**Re: Floodplain GE-Pittsfield/Housatonic River Site
Floodplain Residential and Non-Residential Properties Adjacent to 1½ Mile Reach of
Housatonic River (GECD710 and GECD720)
Addendum to Removal Design/Removal Action Work Plan for the Group 3A and 3B Floodplain
Properties**

Revised Technical Drawings 5 and 6

GENERAL ELECTRIC COMPANY • PITTSFIELD, MASSACHUSETTS
ADDENDUM TO RD/RA WORK PLAN FOR THE GROUP 3A AND 3B FLOODPLAIN PROPERTIES

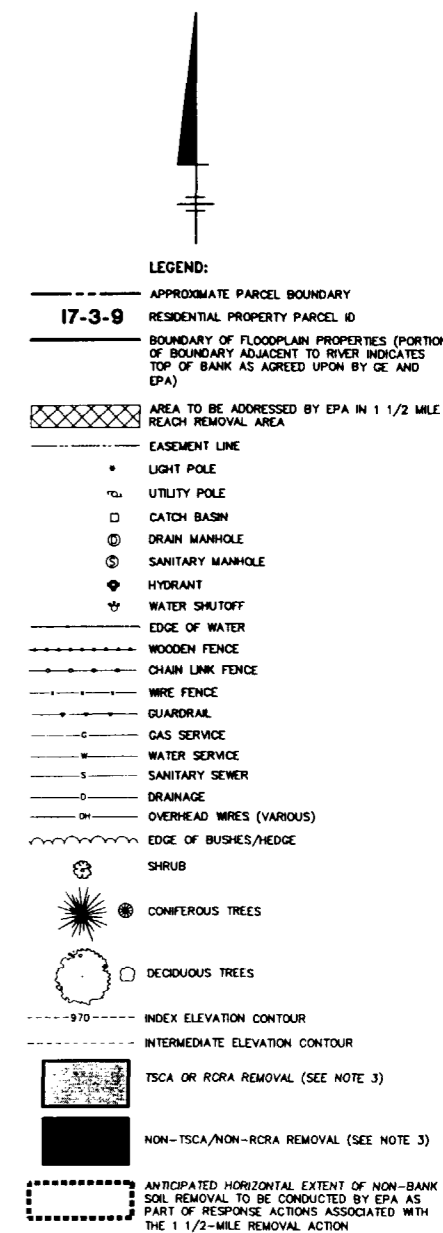
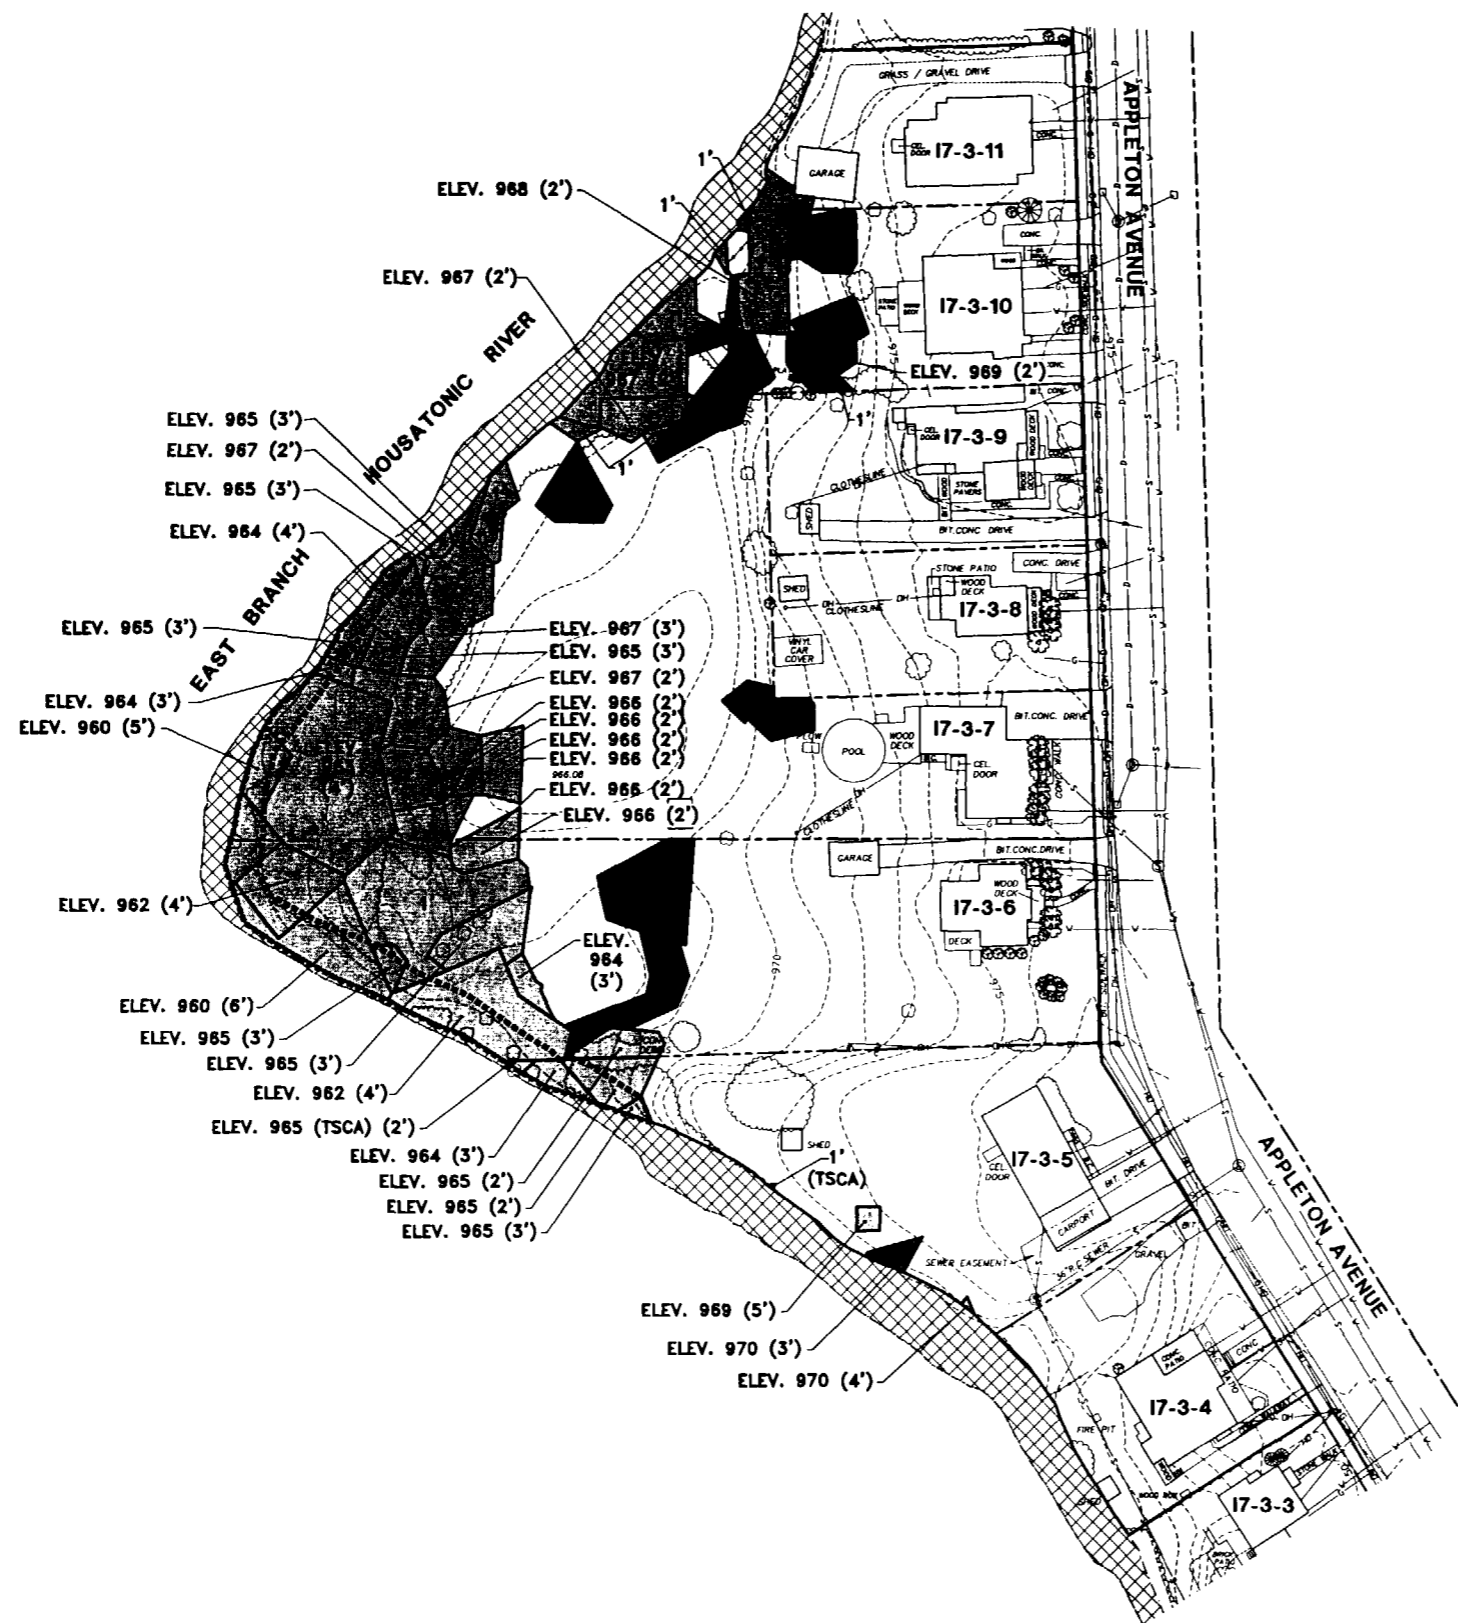
EPA Comment No. 1 – *EPA has reviewed the data set forth in the post-remediation tables in Volume II of the Work Plan. Although those data indicate that the PCB Performance Standards will be met, GE shall consider expanding the excavation limits shown on Technical Drawings 5 and 6 of the Work Plan based on constructability and related factors.*

GE Response – GE has expanded the excavation limits within the Group 3A and 3B floodplain properties based on constructability and related factors. The revised excavation limits are shown on the revised Technical Drawings 5 and 6 provided in Attachment A.

GROUP 3B: 17-3-10
THEISSEN POLYGON MAP
3- TO 4-FOOT DEPTH INCREMENT

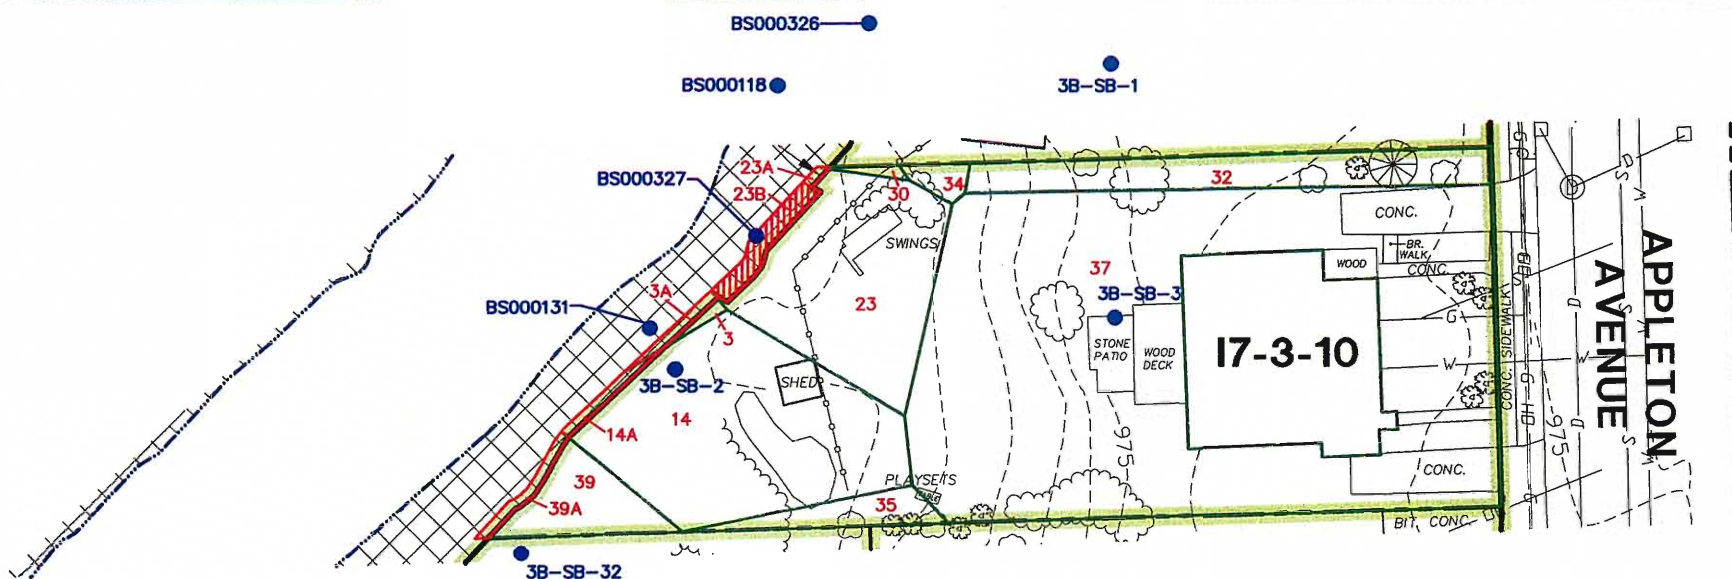
EPA Comment No. 5 – The top of bank boundary within the Group 3A & 3B floodplain properties does not include EPA's 2004 non-bank removals. GE shall review the top-of-bank boundary taking account of those removals, and determine whether or not additional soil removal is required to meet the Performance Standards specified in the Consent Decree.

As indicated in Table E-2, the screening evaluation described above identified two areas that required further assessment – namely, the areas around sample location R47CZ279 in averaging area I7-2-35 (Back) and around sample location RB21565 on Parcel I7-3-10. For those areas, GE revised the detailed PCB evaluations presented in the RD/RA Work Plan to include the EPA non-bank removal areas at Parcels I7-2-35 (Back) and I7-3-10. For this combined averaging area, GE developed PCB polygons for the non-bank EPA removal areas and incorporated these polygons into the post-remediation PCB evaluations presented in the RD/RA Work Plan. These revised polygons are presented in Figures E-1 through E-9, and the revised PCB evaluations for the 1- to X-foot depth increment are presented in Tables E-3 and E-4. The results of these evaluations indicated that the anticipated post-remediation spatial average PCB concentration at Parcel I7-3-10 remained below the 2 ppm Performance Standard (see Table E-3). However, the post-remediation spatial average PCB concentration for averaging area I7-2-35 (Back) increased to above 2 ppm (see Table E-4). The increase in the I7-2-35 (Back) spatial average is predominantly due to the polygon within the EPA non-bank removal area associated with sample R47CZ279 (2- to 3-foot depth increment; 361 ppm). Accordingly, GE will remove soils associated with that polygon. In addition, GE has elected to remove soils associated with polygon 758A in the vicinity of sample location R47EZ244 (1- to 2-foot depth increment) in the same averaging area based on constructability and related factors. This removal will reduce the spatial average PCB concentration in this averaging area to 1.91 ppm, as shown in Table E-5.
